Brookline Place Advisory Committee

Meeting Notes

February 12, 2014

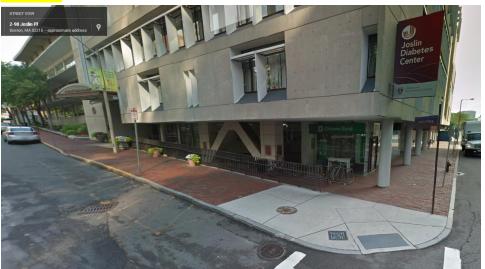
- Outline point 3.b.ii about landscaping on the Route 9 side should include two examples from new LMA construction, showing the building-street relationship preference of the [Dana Farber building on Brookline Avenue, not the Joslin Diabetes center]
 This....

Not this...
